ARCHITECTURAL SUPPLEMENTAL INSTRUCTIONS No. 1

Re: St Jude Catholic Church

Martsolf Architecture Project No. 2307

1. Sheets revised per City comments.

Drawing Title: STORM DRAIN PLAN

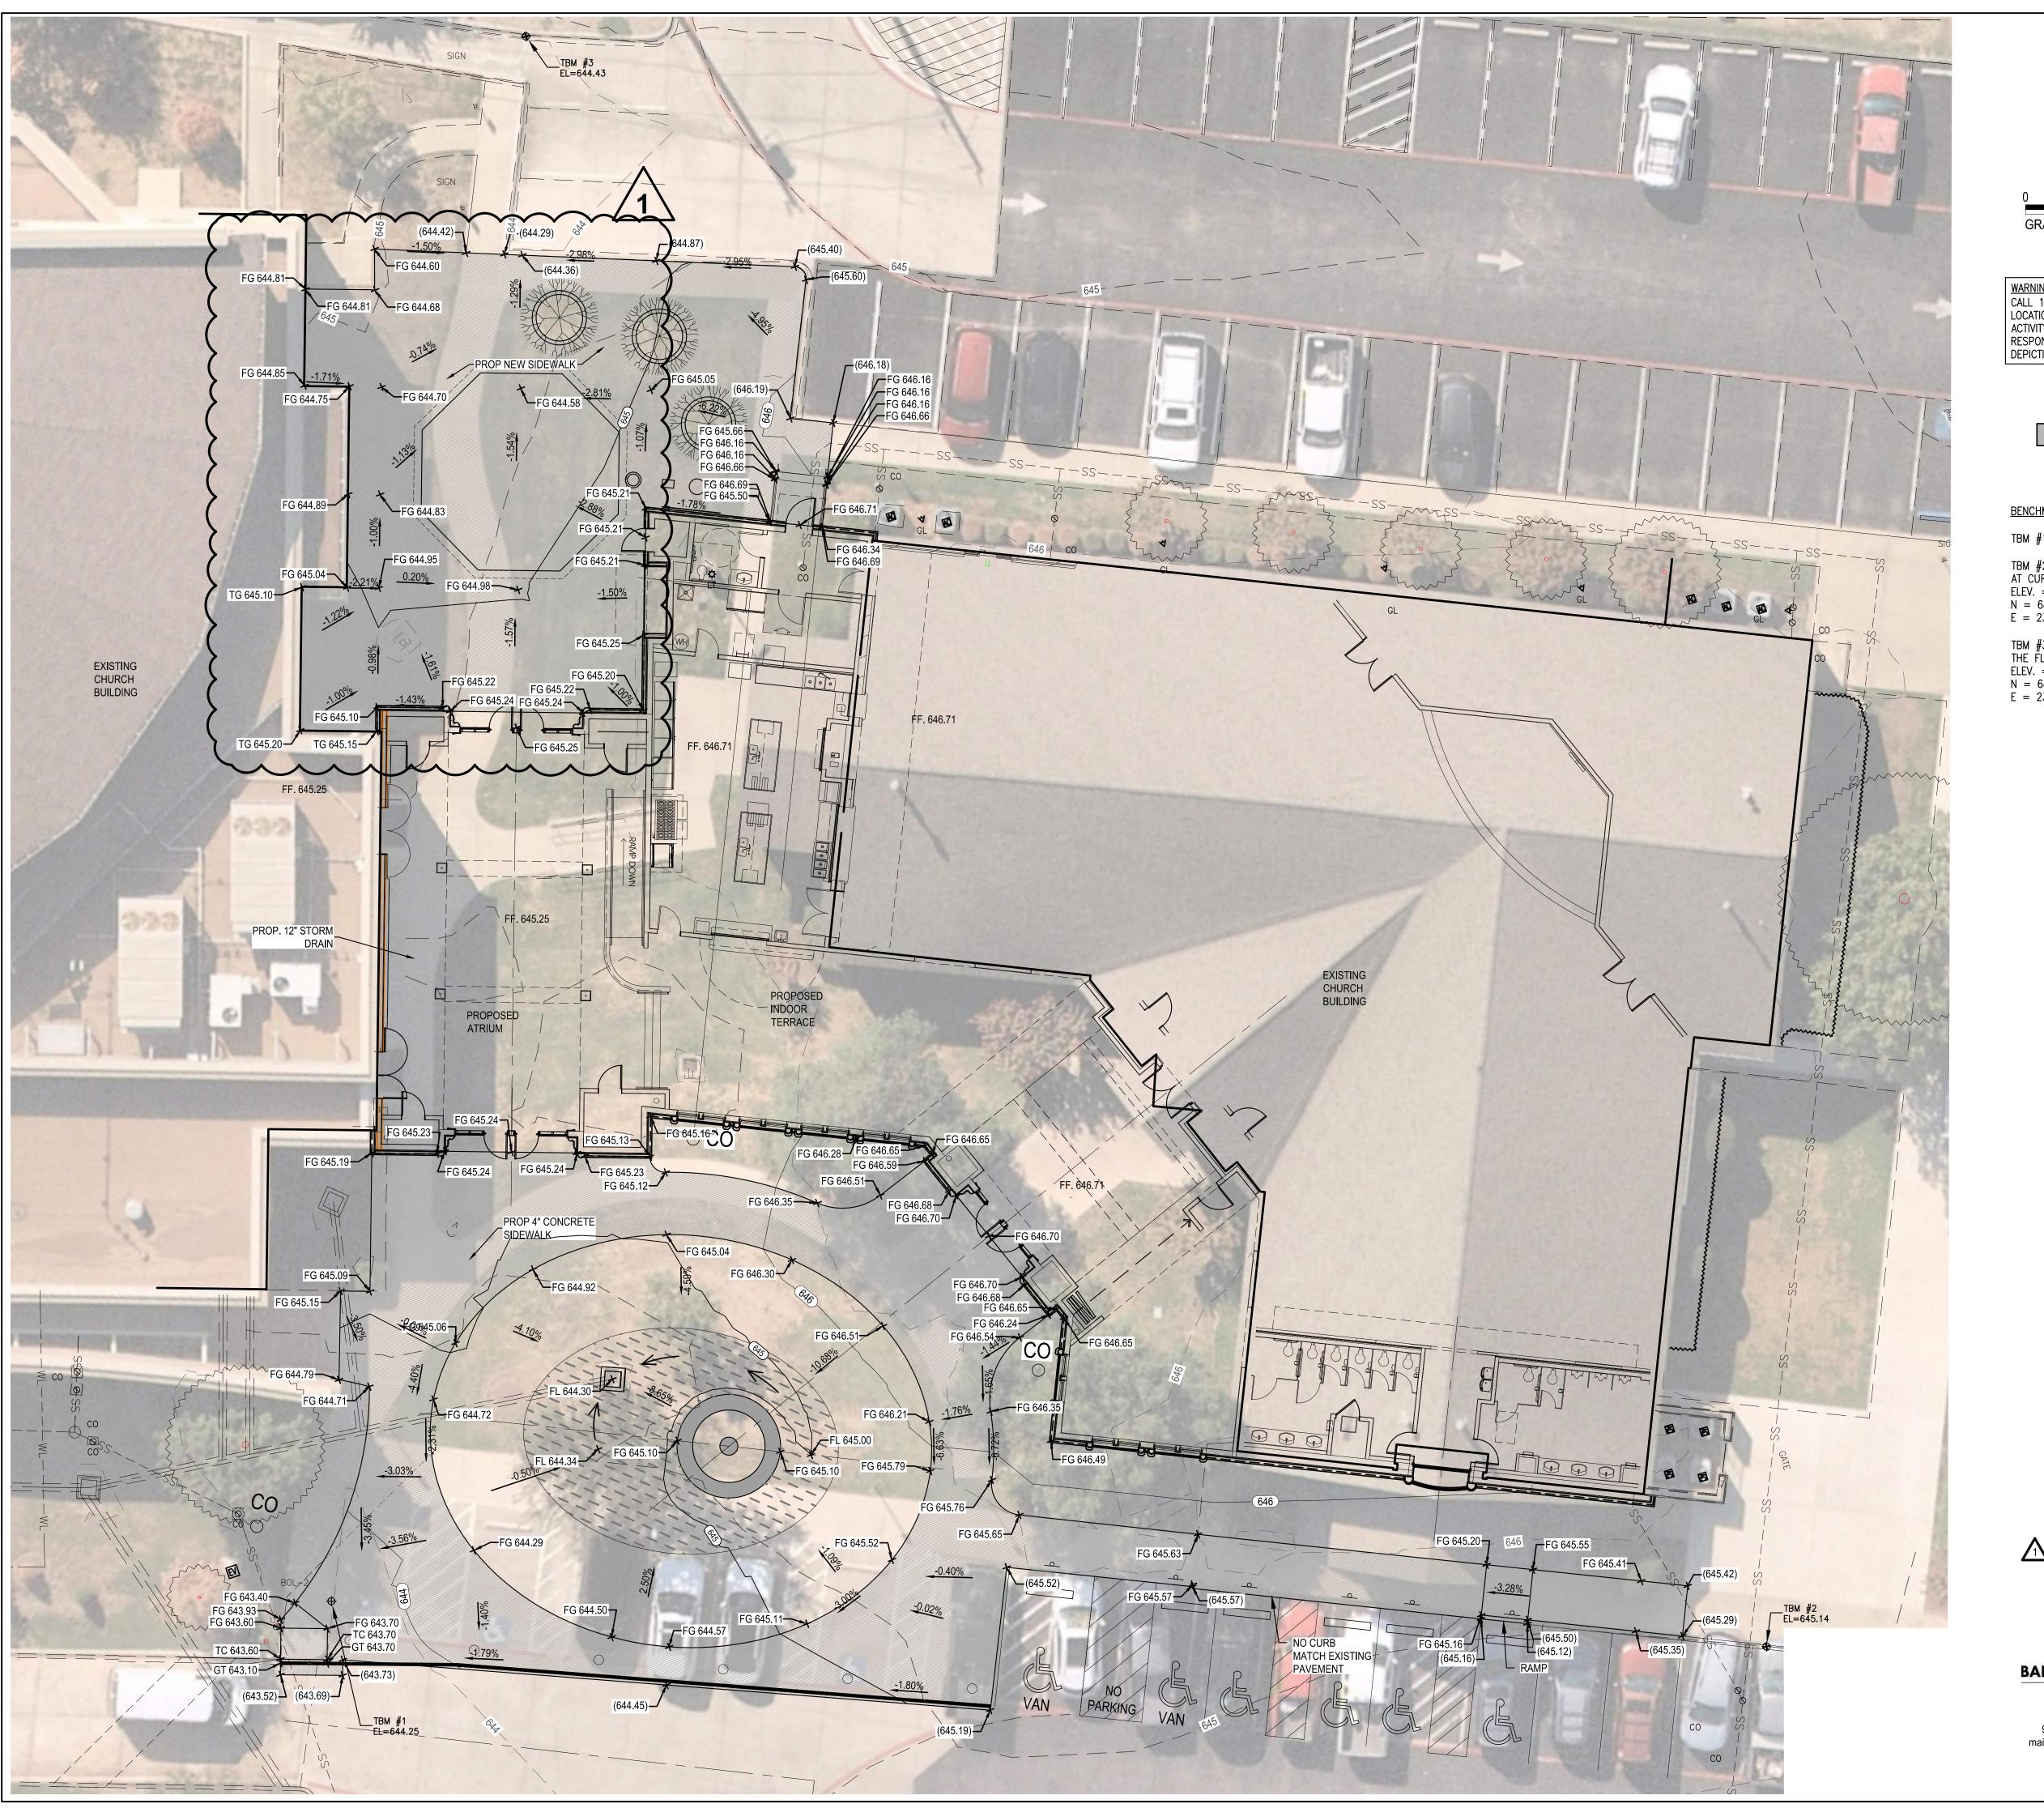
REMOVE STORM DRAIN FROM UNDER BUILDING

Drawing Title: GRADING PLAN Project No. 1/12/2024 2307 Sheet No.

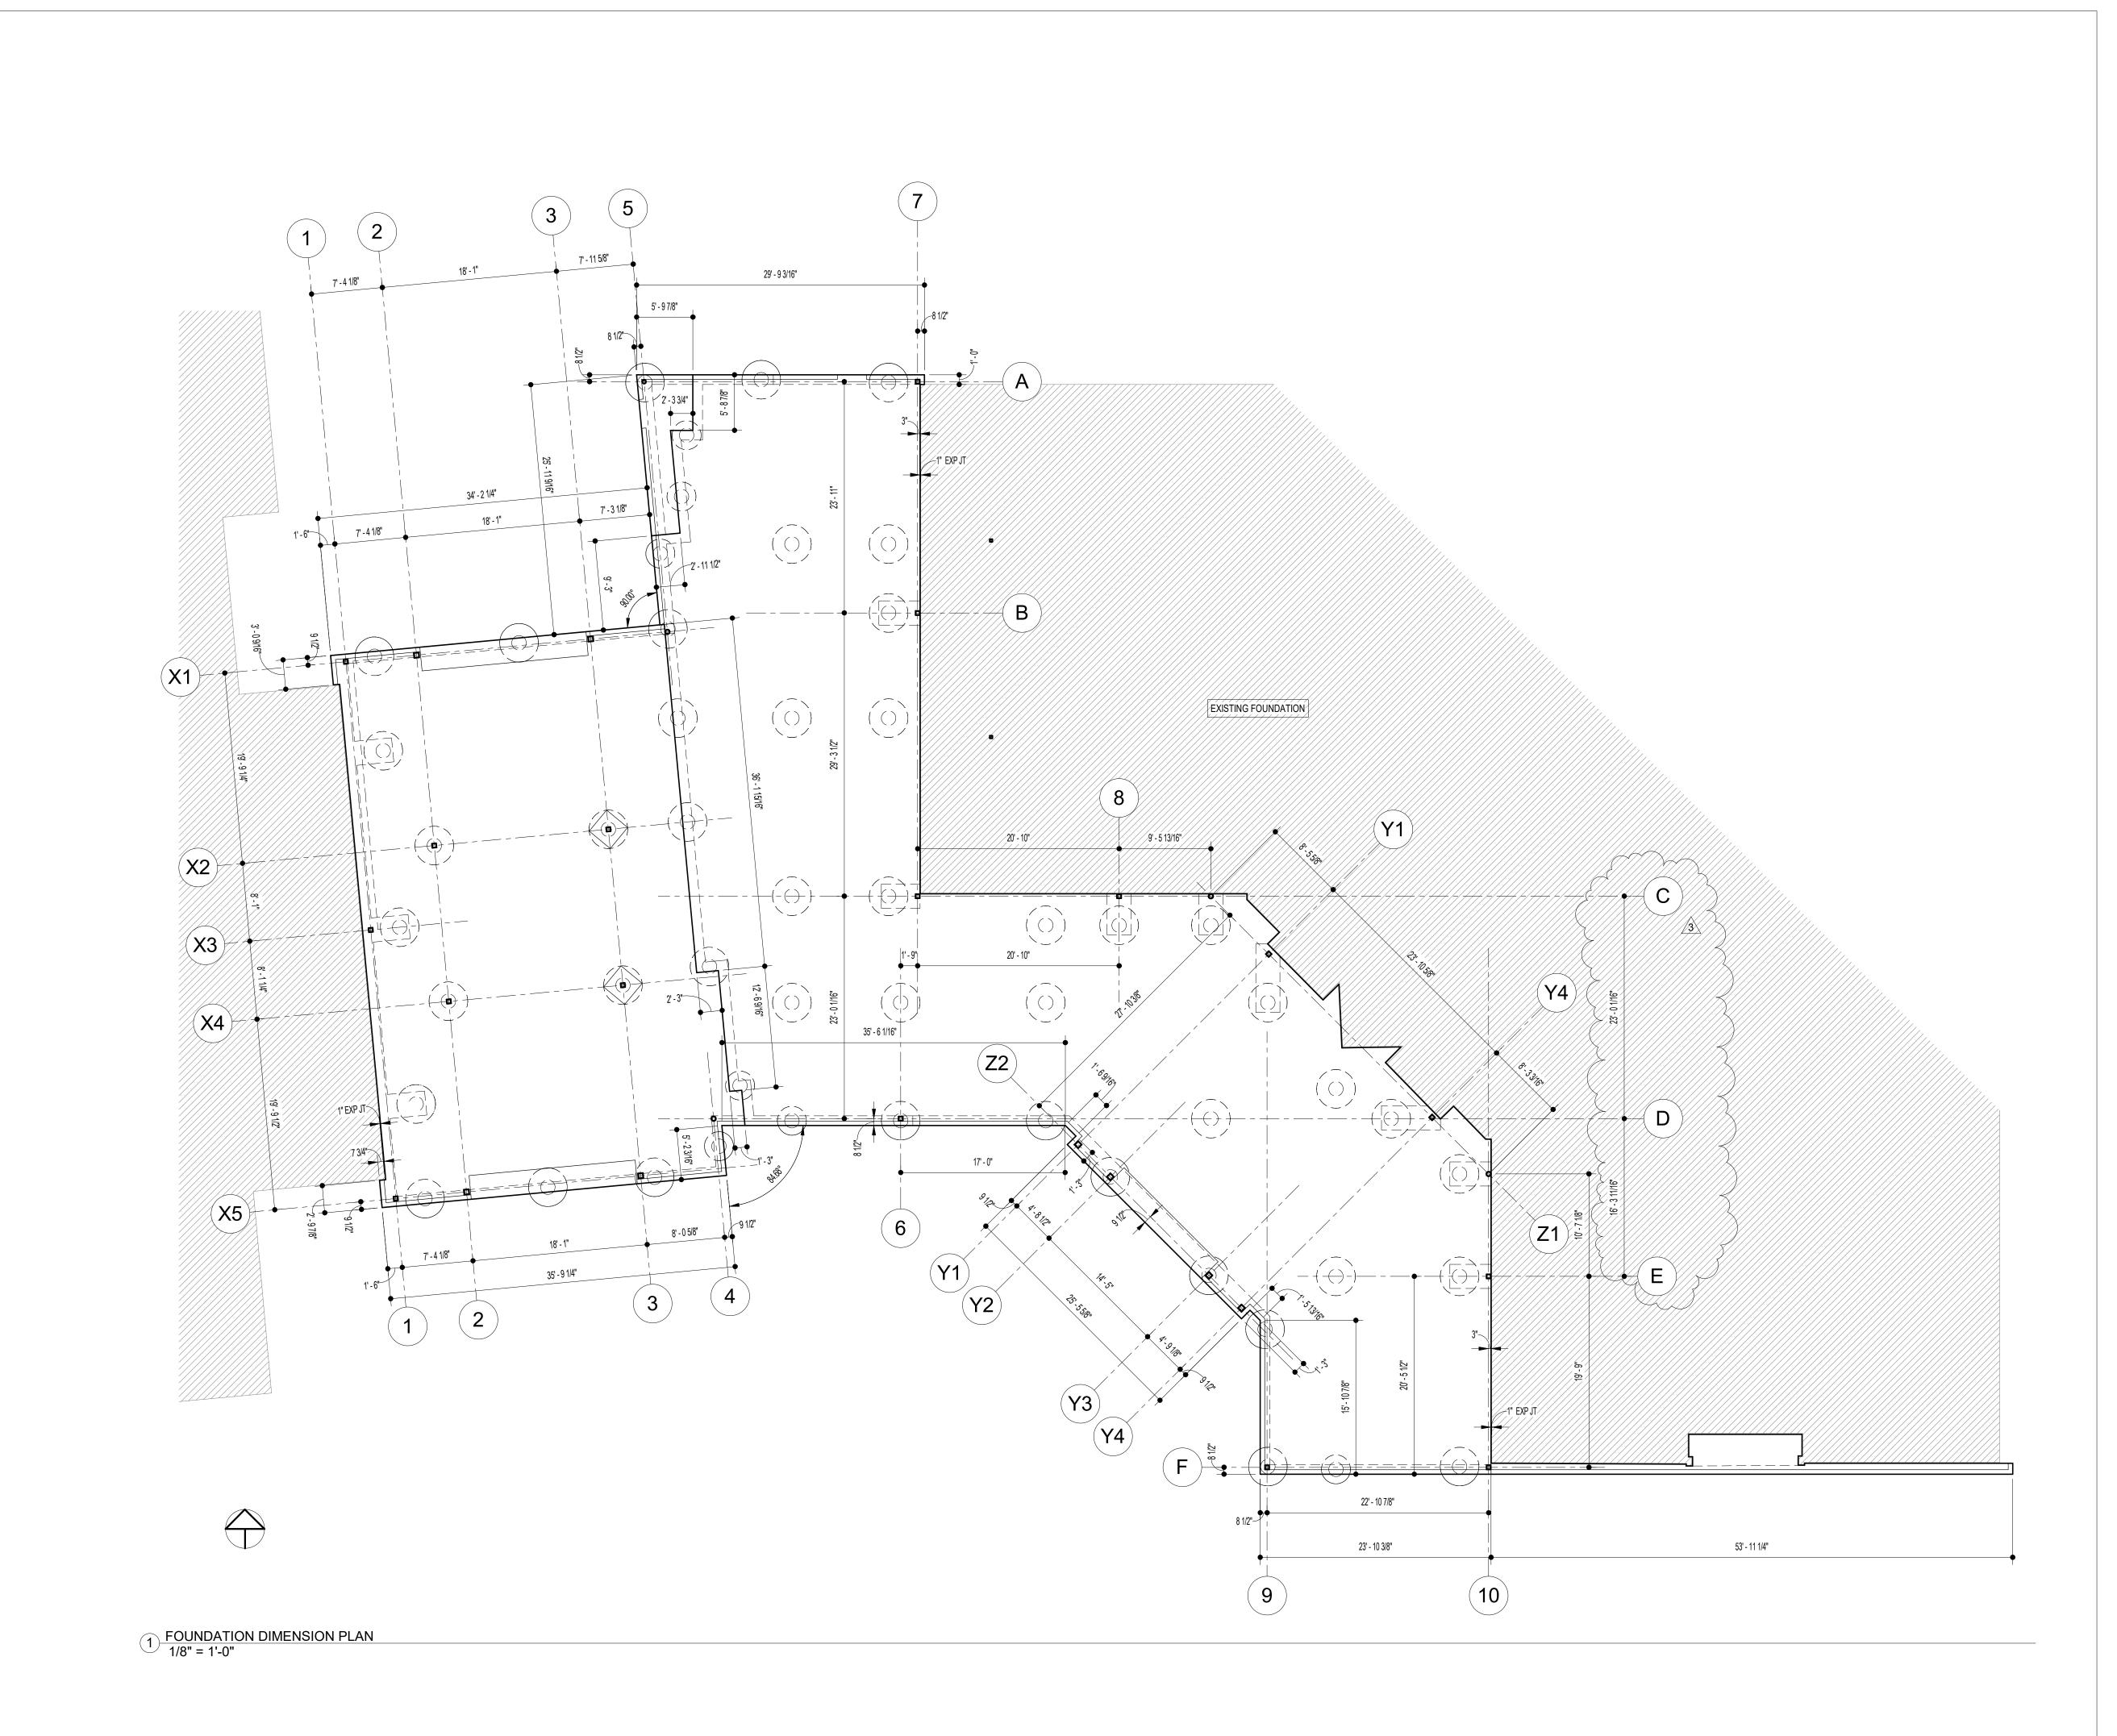
1 REVISE GRADING

ROOF FRAMING PLAN

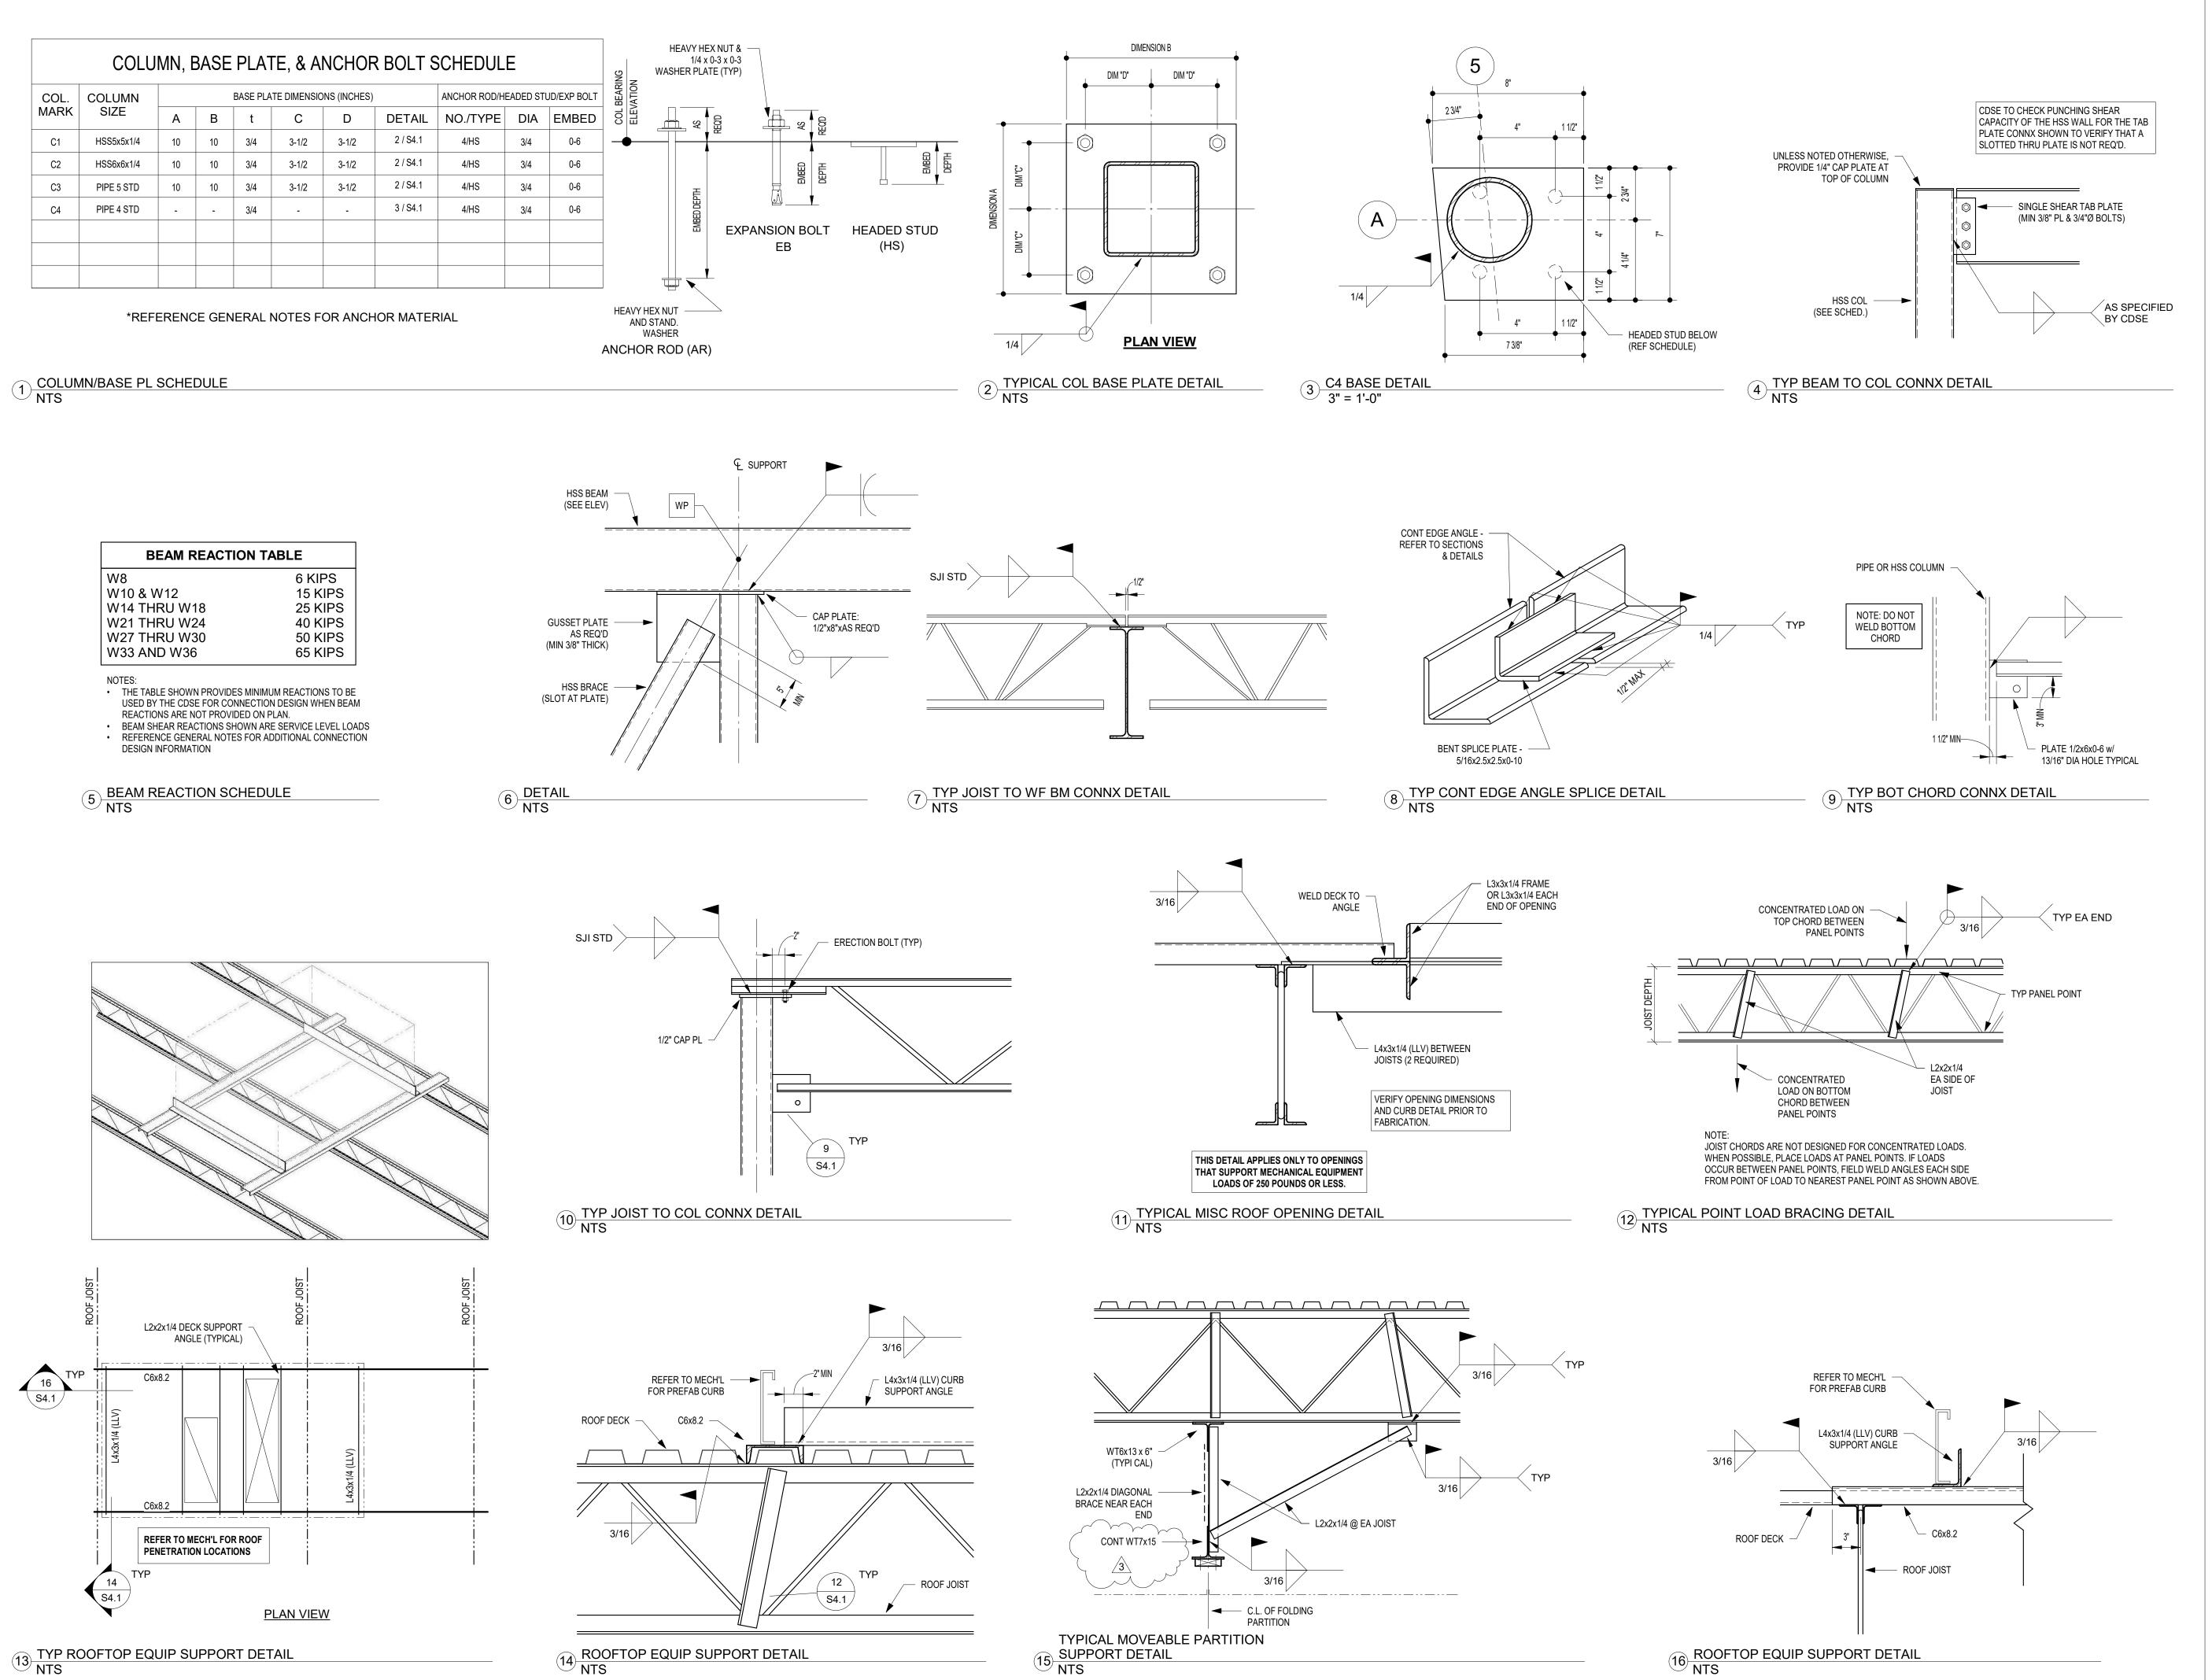
REVISION 3, CITY COMMENTS 4/01/2024
